Our File Ref: B25176TL001_REVA

RE: PROPOSED RESIDENTIAL SUBDIVISION
MERINGANDAN ROAD, MERINGANDAN, QLD 4352
TRAFFIC ENGINEERING RESPONSE TO COUNCIL INFORMATION REQUEST

This letter has been prepared in response to Toowoomba Regional Council's (TRC) Information Request dated 13 October 2025 (Ref: RAL/2025/5992). The Information Request is in relation to a Reconfiguring a Lot (ROL) Development Application (DA) for a residential subdivision located along Meringandan Road, Meringandan, QLD 4352. The proposal involves 199 residential lots and two (2) balance lots. The site is formally described as Lot 3 on AG4138 and Lot 1 on RP27298 with a total site area of approximately 36.813ha.

Title:
TRC WCV
SWEEP PATH ASSESSMENT

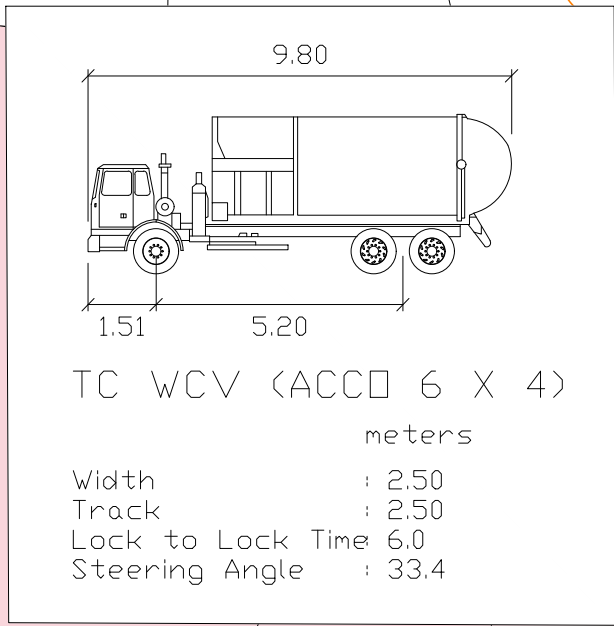
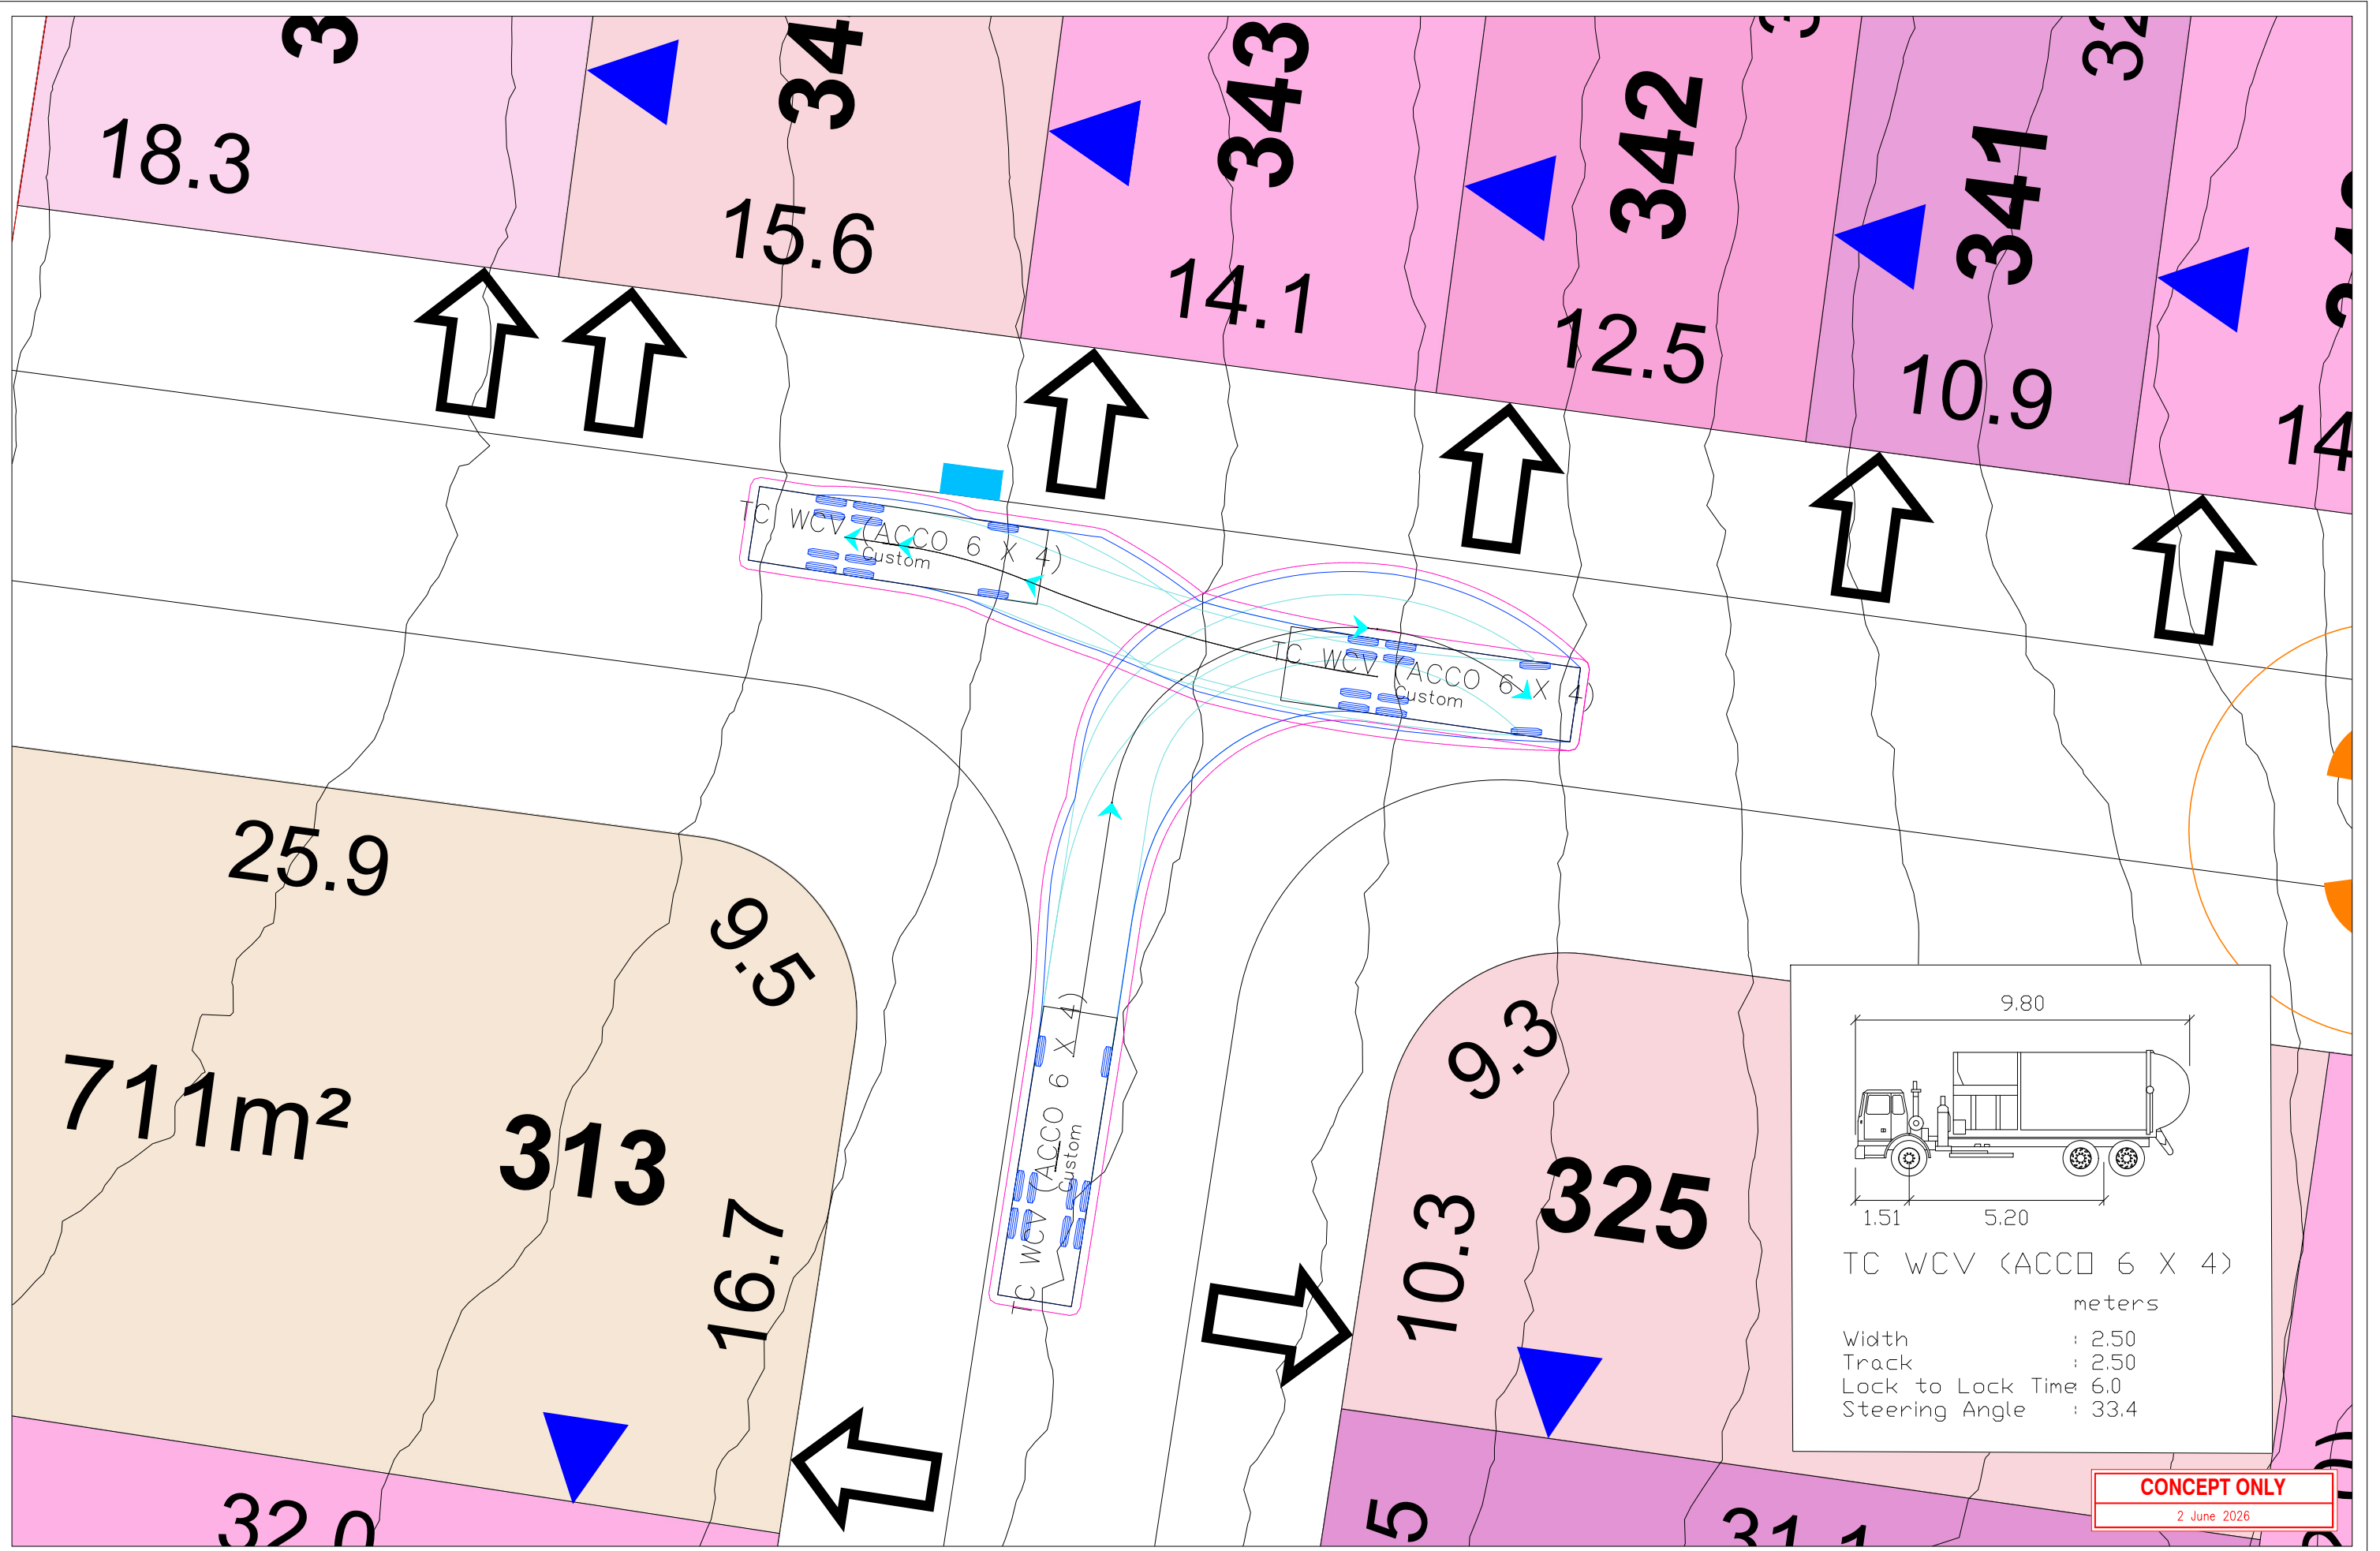
It is unclear how Lots 344 and 345 can be serviced by a waste collection vehicle in forward gear as no turnaround has been provided.

Provide amended plans which demonstrate how Lots 344 and 345 can be appropriately serviced by a waste collection vehicle.

Please refer to the updated site layout in Attachment 1. Bin pads have been provided adjacent to Lot 344 to facilitate refuse collection for Lot 345. A swept path assessment has been undertaken using Council's refuse collection vehicle and is enclosed within Attachment 2. The swept path demonstrates that the refuse vehicle will be able to reverse into the stub road to service Lots 344 and 345.

Title:
FUNCTIONAL LAYOUT PLAN

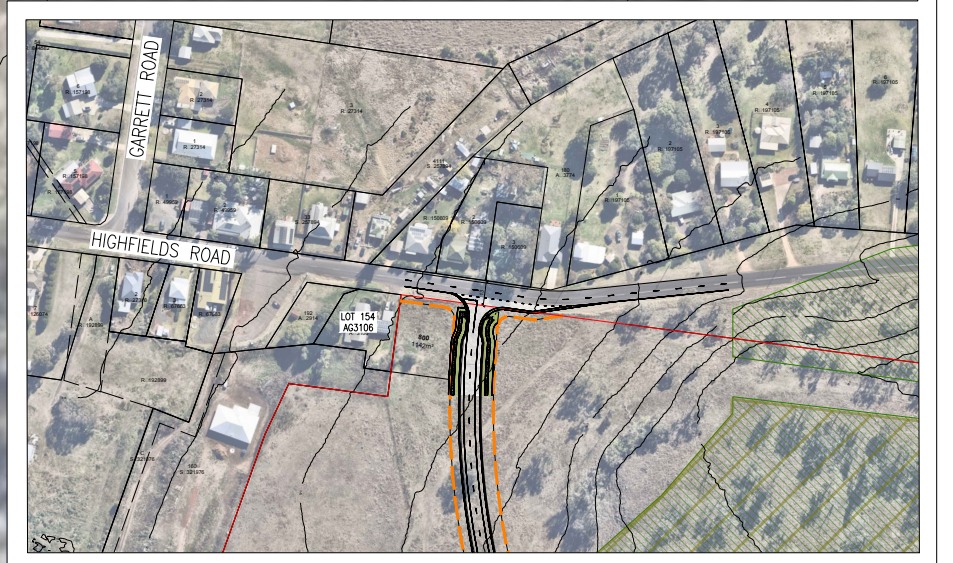
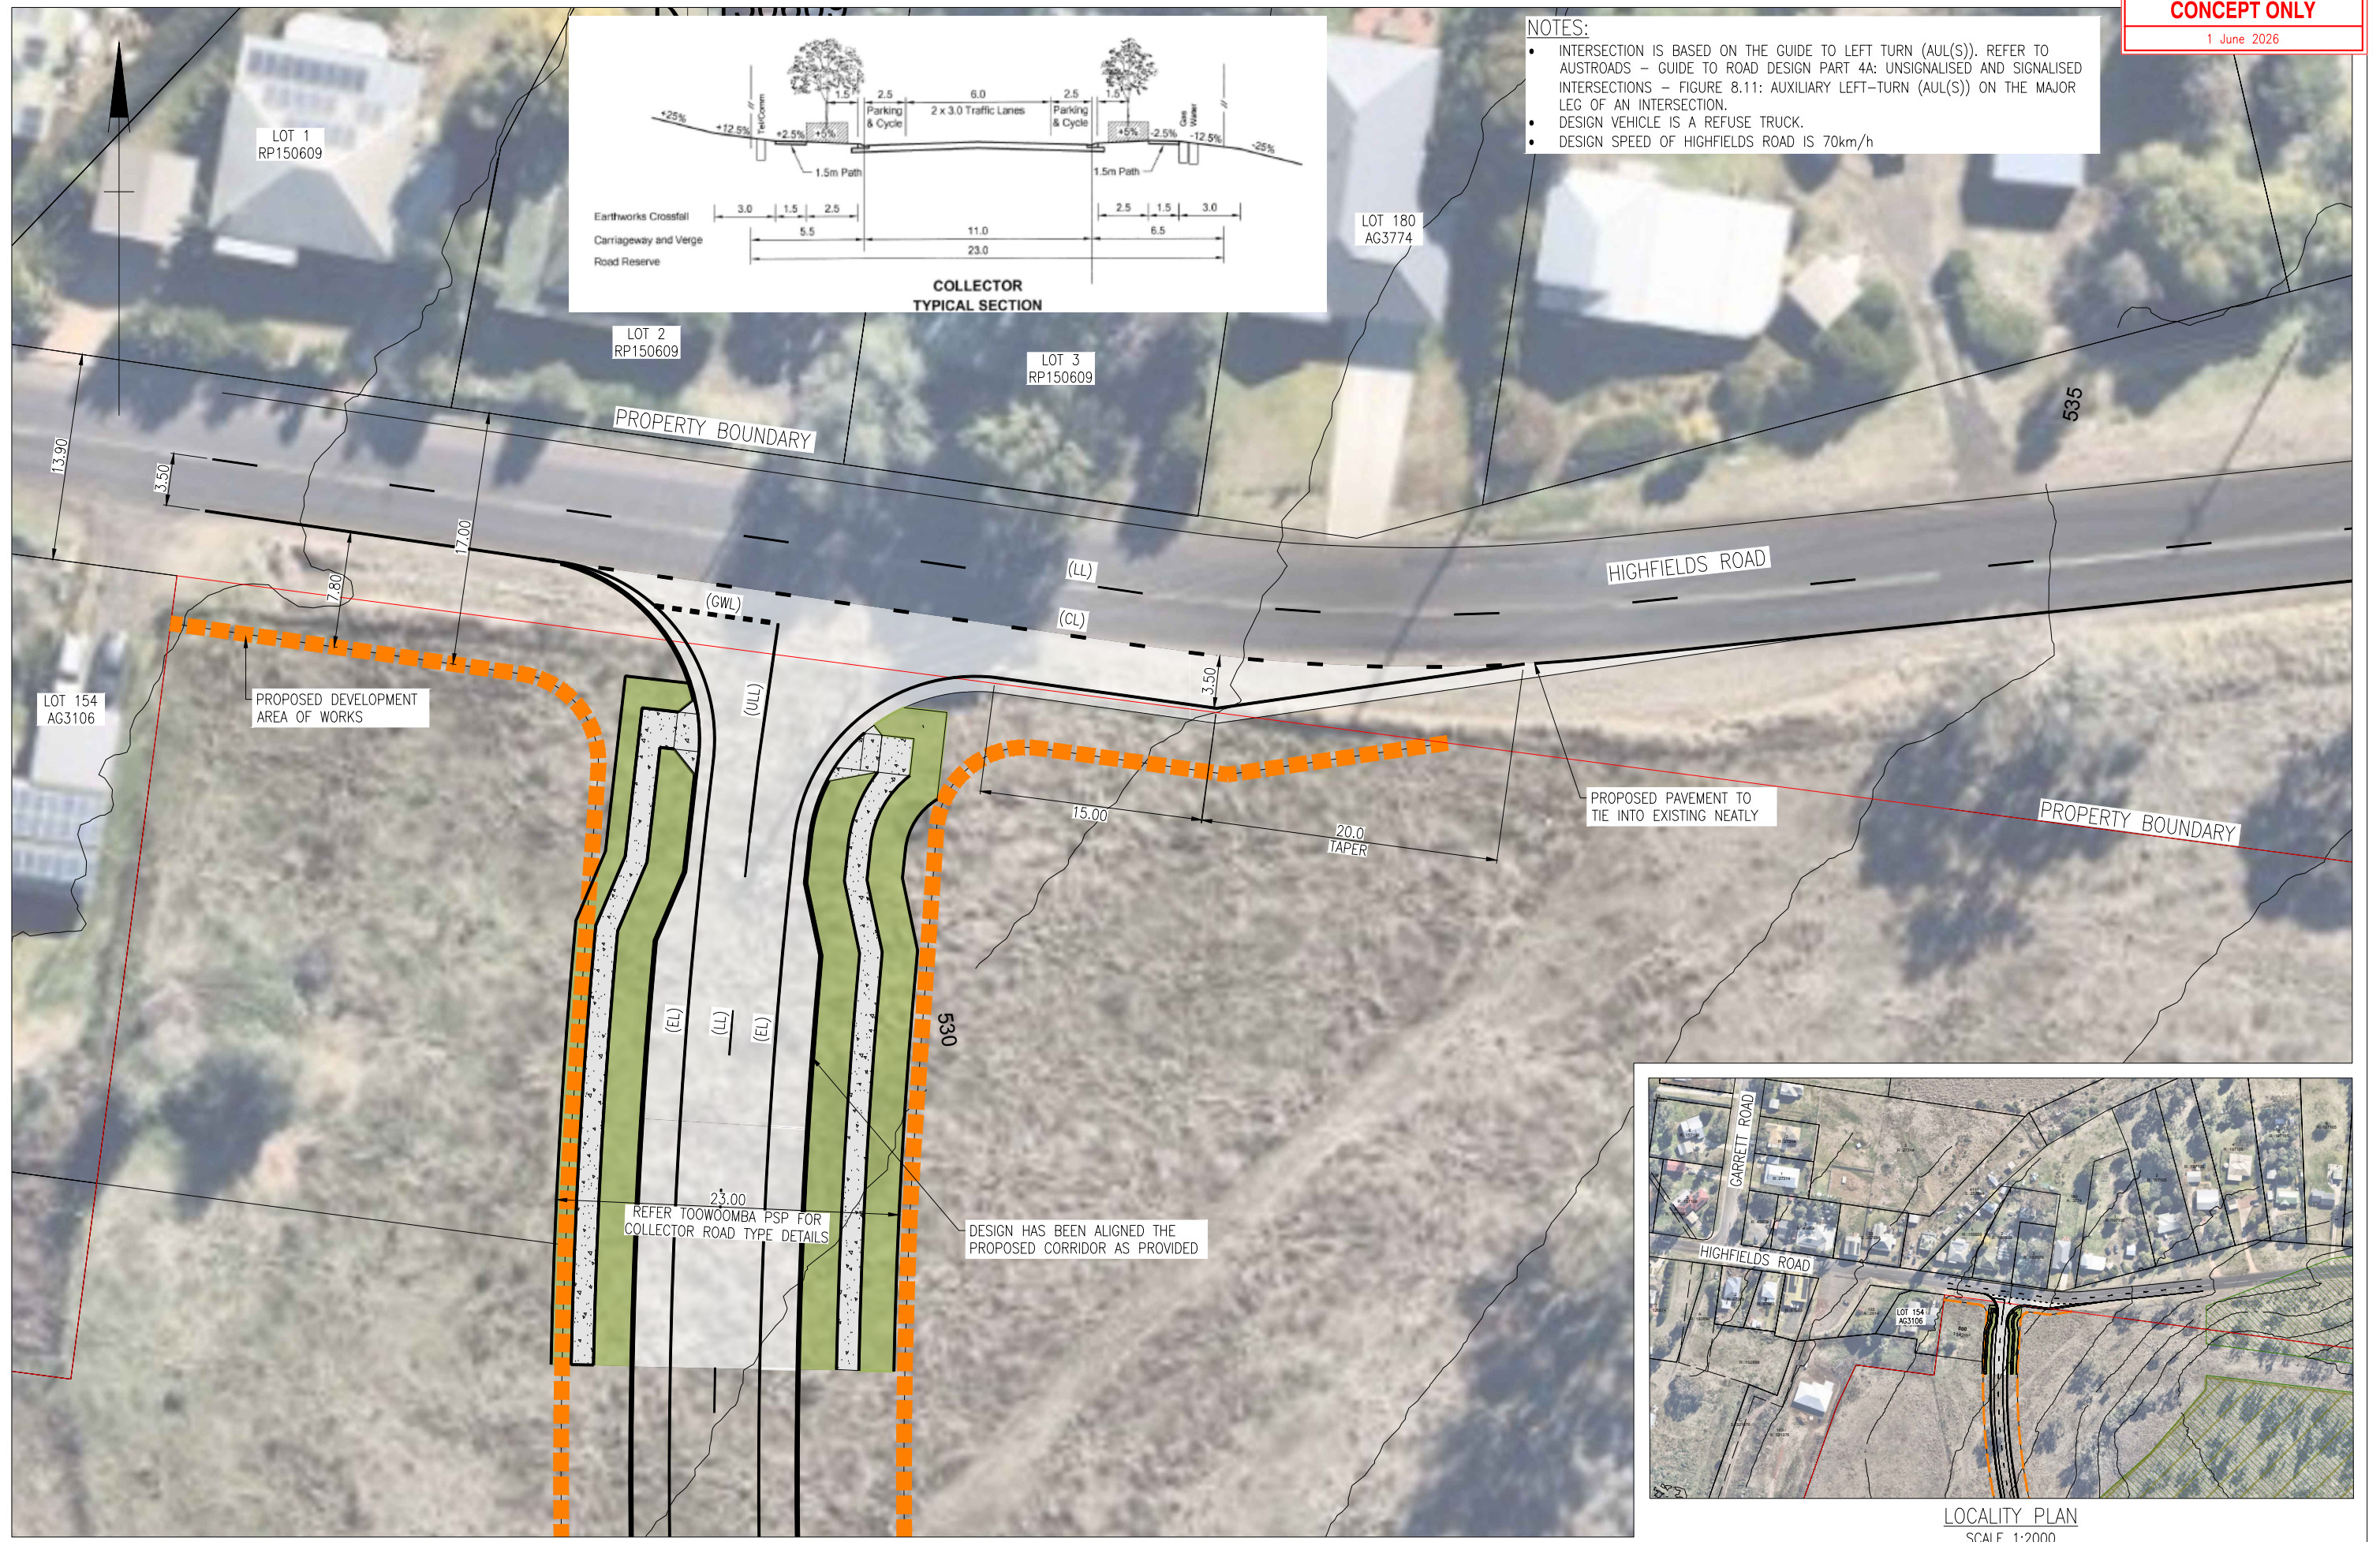
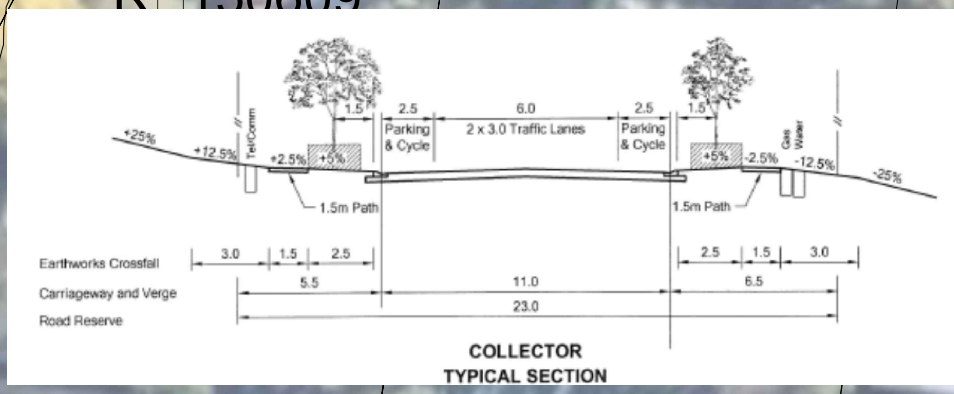
- (f) Has not recognised the constraints of the site with respect to road dedication requirements on Main Street;*
- (g) Has not demonstrated how maximum speeds on local access streets will be controlled given there are some local access streets up to 280m in length without any curve restraints and*

- (f) Turn warrants required at Main Street/Development Access including an intersection layout recognising existing services and pedestrian connectivity. The 14.1m proposed road dedication on Main Street is excessive given the constraints of the site;*

Please refer to the updated Traffic Impact Assessment and functional layout plan enclosed within Attachment 3 of this letter, the road dedication has now been reduced to 3.1m to provide a 17.0m road reserve across the frontage, which better aligns with the available road reserve to the west.
